**IEEE P802.11  
Wireless LANs**

<b>LB279 comment resolutions for measurement sounding phase of TB ranging</b>
---

This submission discusses resolutions to the following 5 CIDs for measurement sounding phase of TB ranging from LB279 of TGbk D1.0.

**11be D5.0: Figure 9-87a HE variant Common Info field format and Figure 9-87b EHT variant Common Info field format**

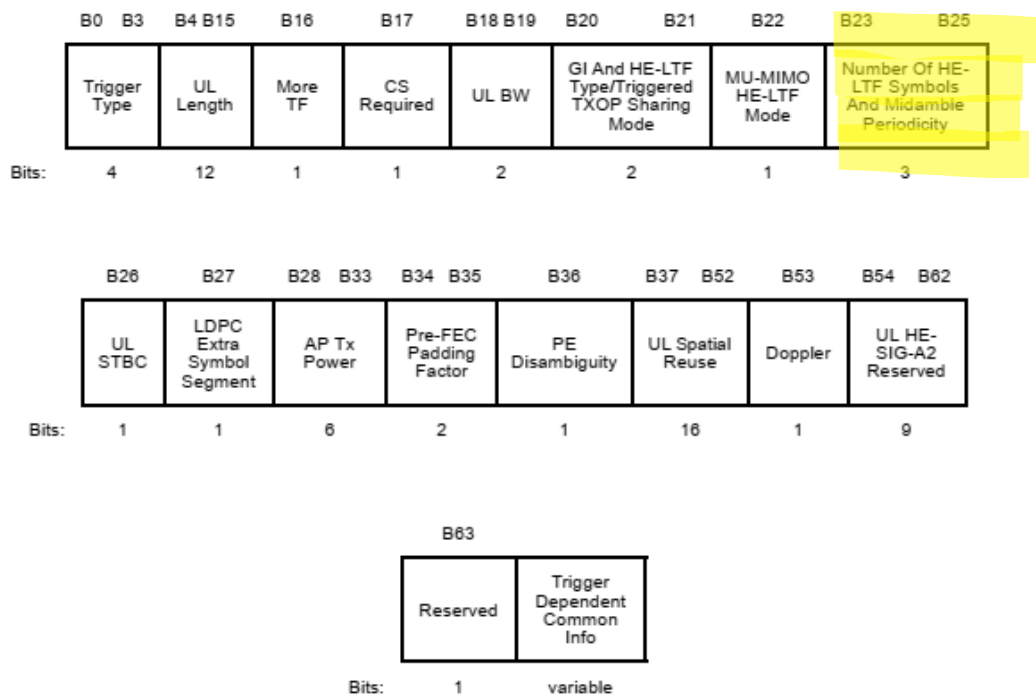
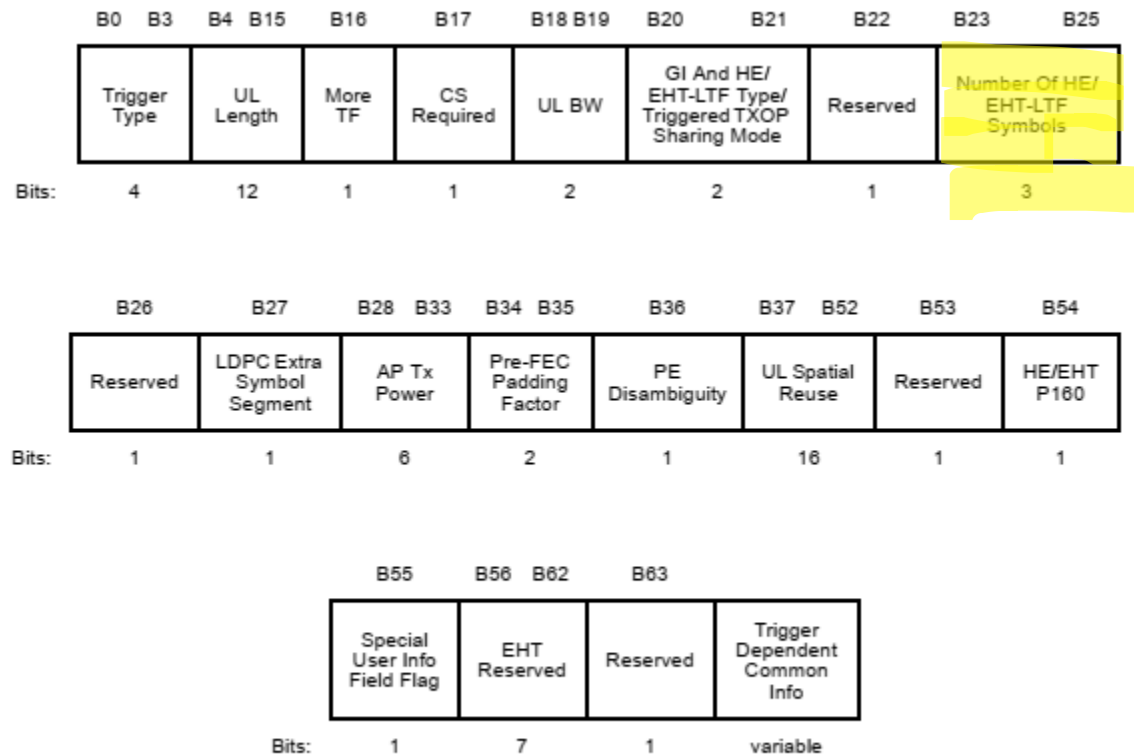
CID	Cat	Page	Comment	Proposed Change	Resolution
1059	T	34.28	Is this requirement only to be defined for HE-LTF symbols, or in general for LTF symbols	Please check if this is general text for LTF symbols and in case strike out "HE-"	Revised  <b>TGbk editor:</b> Please replace P34L28-33 with the following text: — (#1059) The product of the number of LTF repetitions, indicated in each of the I2R Rep subfields of the User Info fields, and the number of LTF symbols, indicated in the Number Of HE-LTF Symbols And Midamble Periodicity subfield in the HE variant Common Info field or in the Number Of HE/EHT-LTF Symbols subfield in the EHT variant Common Info field, shall not exceed the RSTA Assigned I2R LTF Total for any of the ISTA triggered by this Trigger frame.

- The product of the number of LTF repetitions, indicated in each of the I2R Rep subfields of the User Info fields, and the number of HE-LTF symbols, indicated in the Number Of HE-LTF Symbols And Midamble Periodicity subfield in the Common Info field, shall not exceed the *RSTA Assigned I2R LTF Total* for any of the ISTA triggered by this Trigger frame.
